[Docket No. FAA-2013-0724; Directorate Identifier 99-CE-013-AD; Amendment 39-17691; AD 99-26-19 R1]

Airworthiness Directives; Piper Aircraft, Inc. Airplanes

ACTION: Final rule.

Procedures and Requirements for Ultrasonic Inspection of Piper Wing Lift Struts

Figure 1

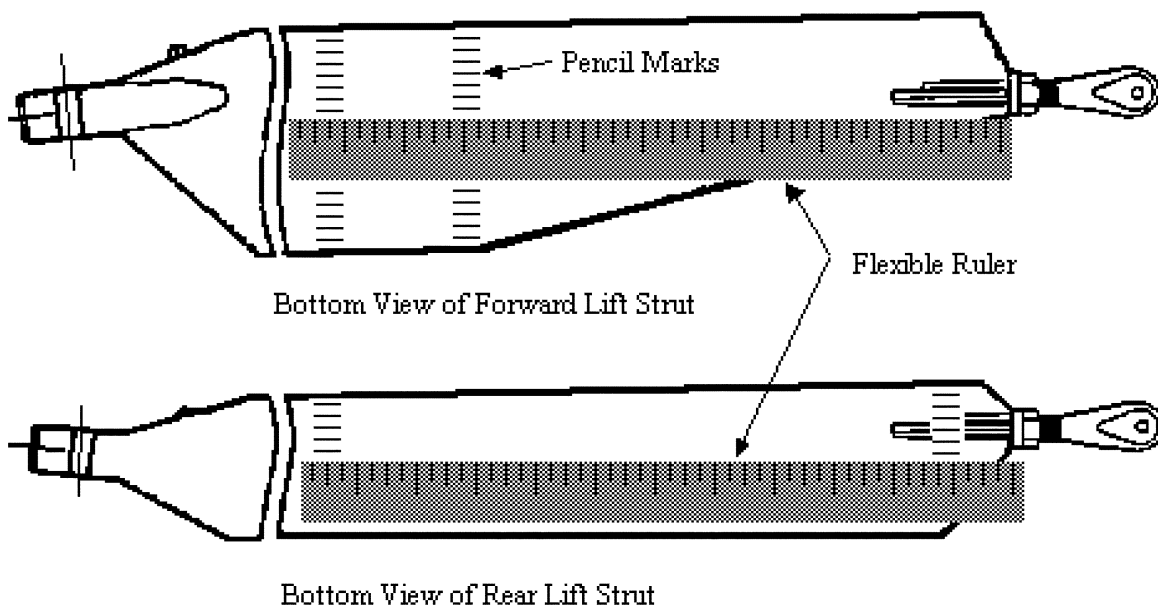
2. Using a flexible ruler, draw a $\frac{1}{4}$ -inch grid on the surface of the first 11 inches from the lower end of the strut as shown in Piper SB No. 528D, dated October 19, 1990, or Piper SB No. 910A, dated October 10, 1989. This can be done using a soft (#2) pencil and should be done on both faces of the strut. As an alternative to drawing a complete grid, make two rows of marks spaced every $\frac{1}{4}$ -inch across the width of the strut. One row of marks should be about 11 inches from the lower end of the strut, and the second row should be several inches away where the strut starts to narrow. Lay the flexible ruler between respective tick marks of the two rows and use tape or a rubber band to keep the ruler in place. See Figure 1.
